ISO/IEC JTC 1/SC 17
Cards and personal identification
Secretariat: BSI (United Kingdom)

Document type: Disposition of Comments Report

Title: Disposition of comments: FCD ISO/IEC 10373-6:2011/PDAM9 — Identification cards — Test methods — Part 6: Proximity cards — AMENDMENT 9: Test methods for electromagnetic disturbances

WORK ITEM: 55977

Noise requirements for the electromagnetic disturbance test

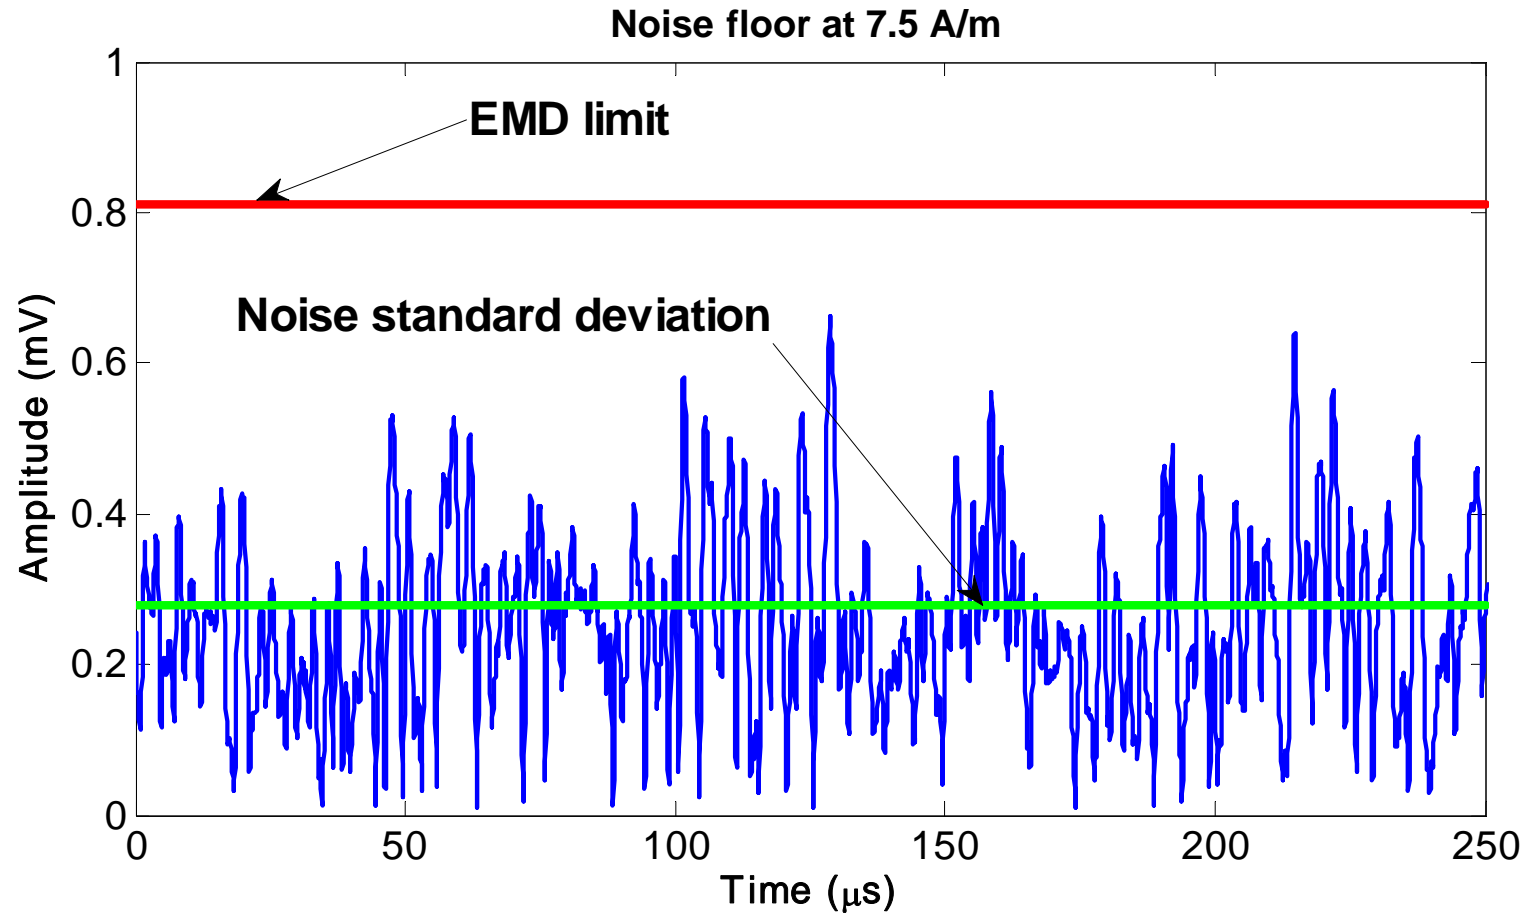
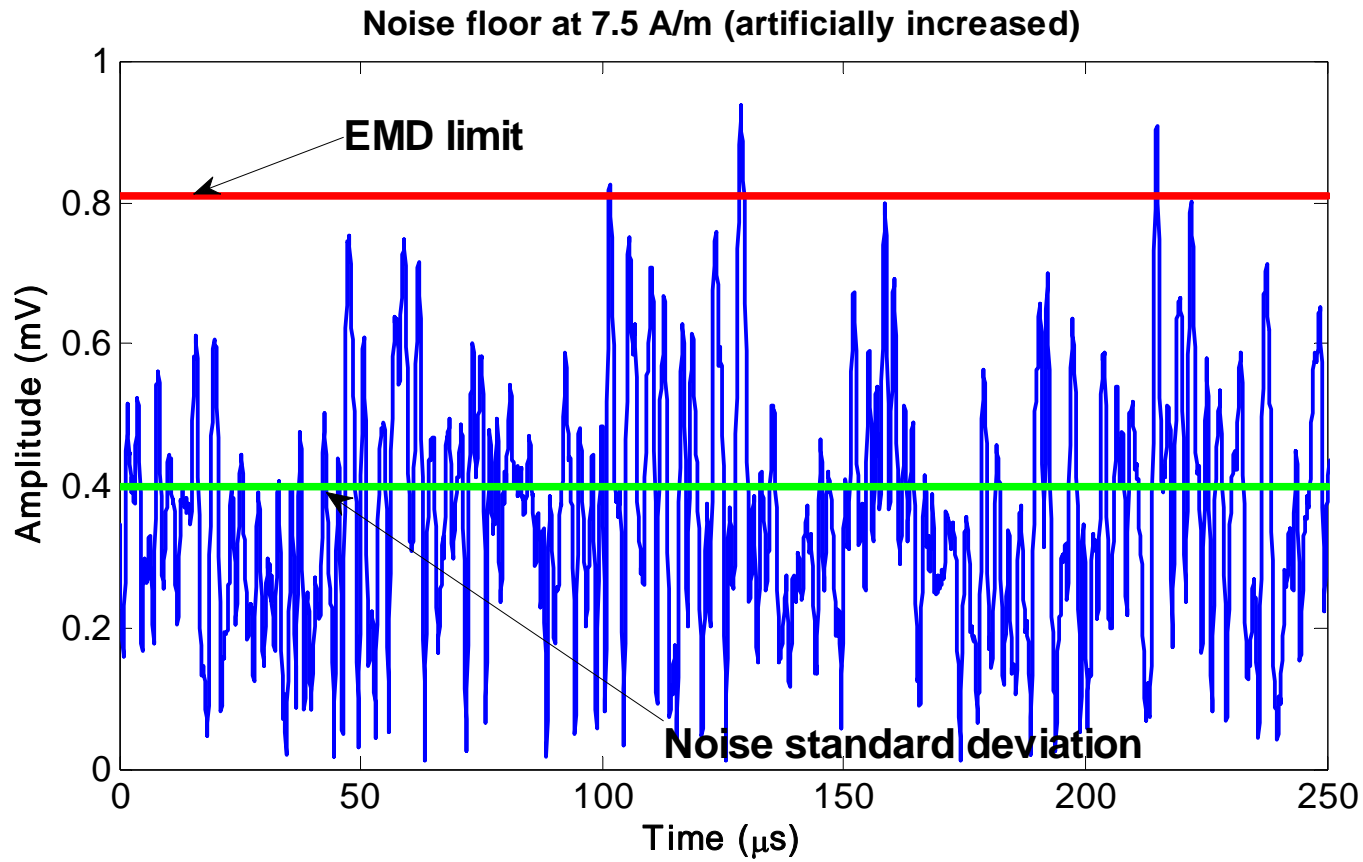
Test setup noise level SHALL be much smaller than the EMD limit:

A factor two is not enough !

Noise floor = EMD limit / 3: Low probability to exceed the EMD limit

Noise floor = EMD limit / 2

Few spikes above the limit
PICC will FAIL the test

- Recent change of noise floor precondition leads to wrongly detected PICC test failures
- Noise standard deviation **MUST** be at least 3 times smaller than the EMD limit
- This precondition is perfectly achievable even at high field strength as demonstrated in previous contributions by JRC, Gemalto, IFX, BDr, NXP, and others (TF2N 645, 648, 649, 651,654)

The noise floor test is passed if the noise standard deviation is at least **three times** smaller than the EMD limit $V_{E,PICC}$, when measured as described in 5.2.3.1.

The noise floor test is passed if the noise standard deviation is at least **two times** smaller than the EMD limit $V_{E,PICC}$, when measured as described in 5.5.3.1.
